REGIONAL DISTRICT OF OKANAGAN-SIMILKAMEEN

CAMPBELL MOUNTAIN SANITARY LANDFILL AND OLIVER LANDFILL OPERATIONS

RDOS-21-FIN-11

ADDENDUM NO. 1

Figure E-3: Drawing showing proposed composting facility location that is scheduled for construction in 2022.

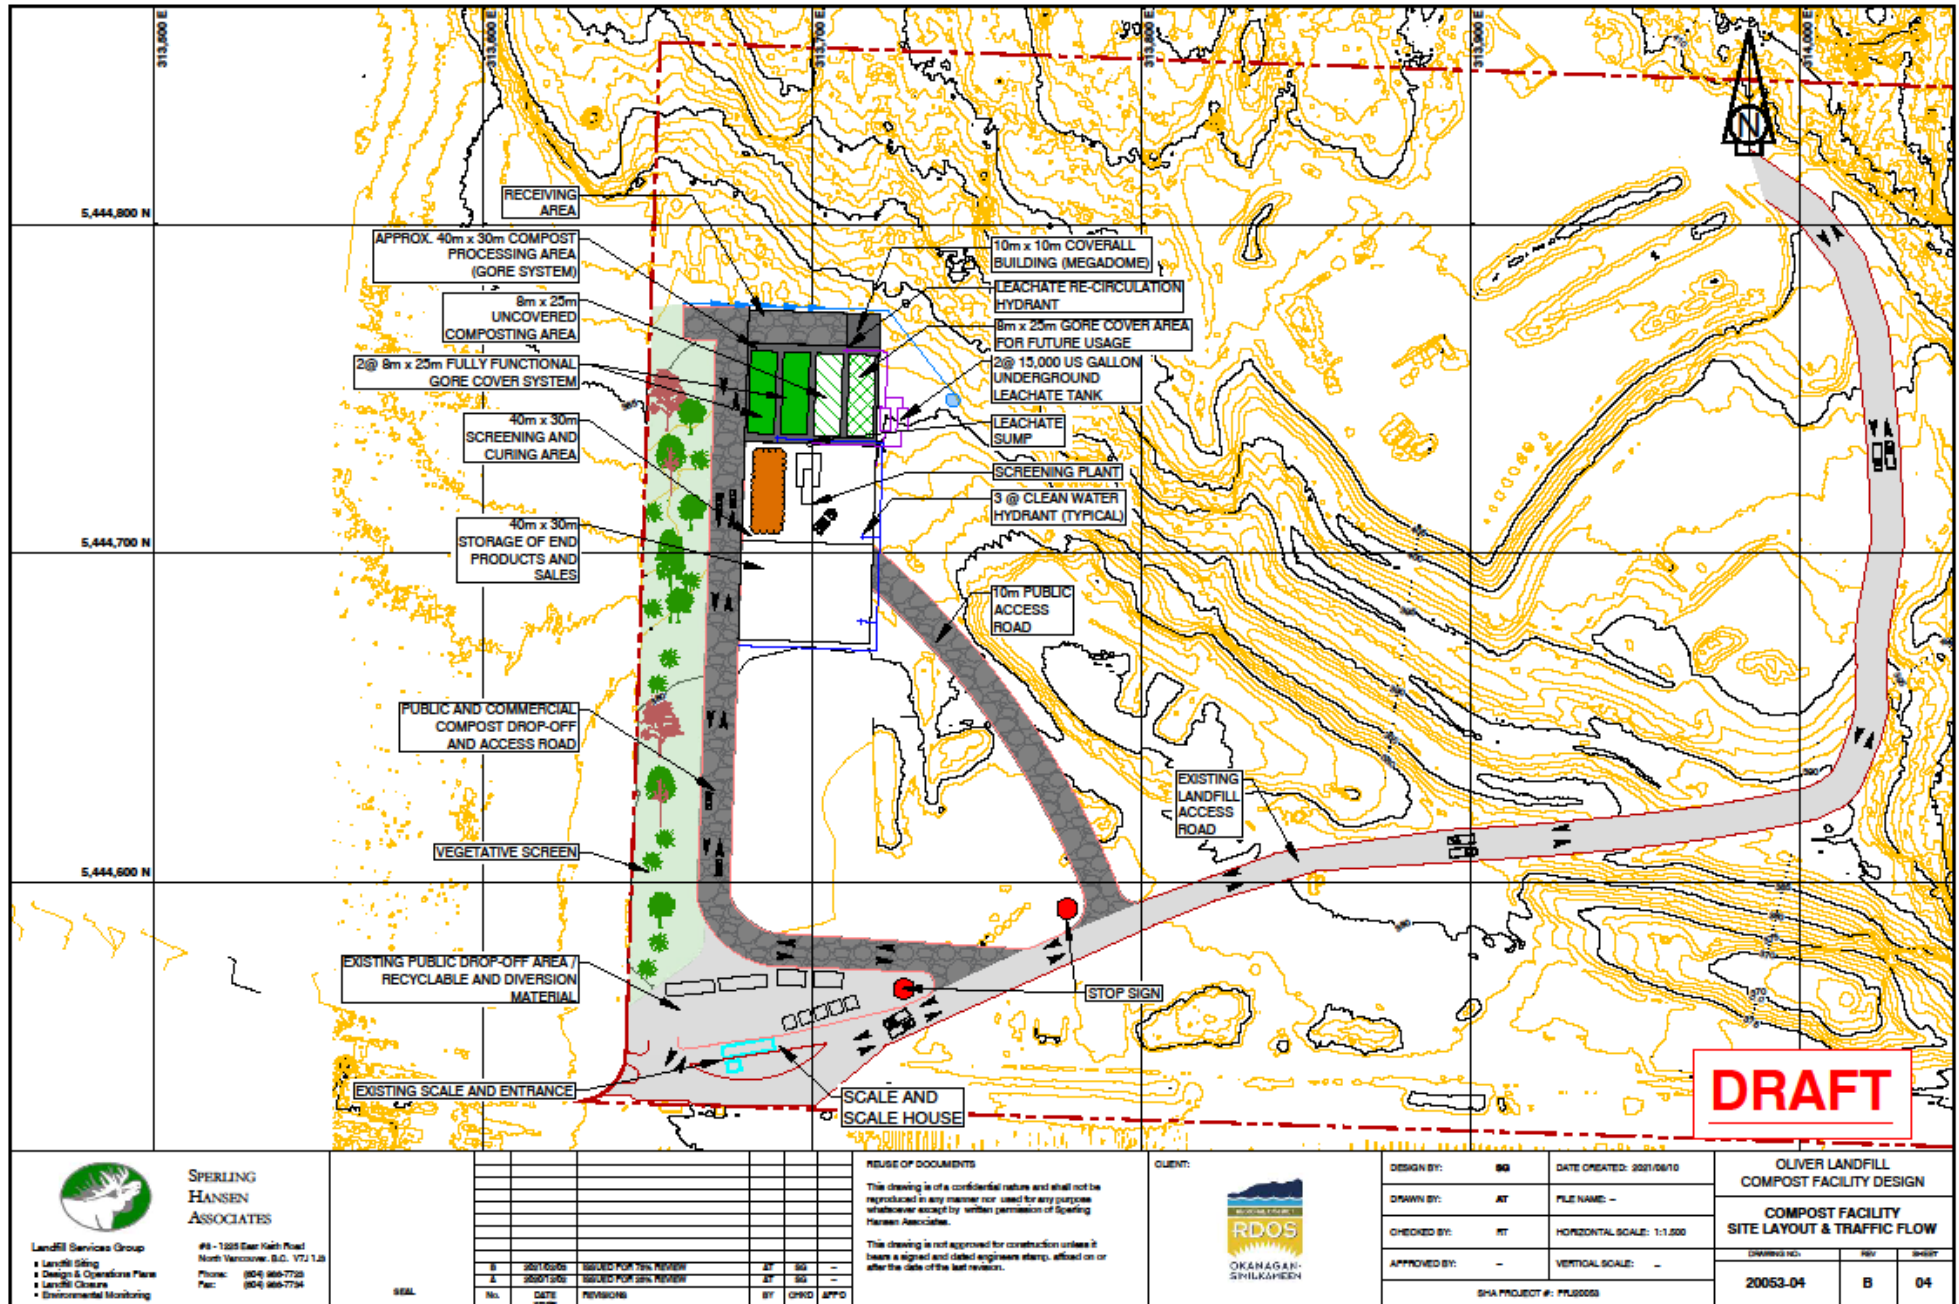
Question: is there an updated drawing available for the OSL compost facility?

Answer: Yes, the drawing is included on the next page.
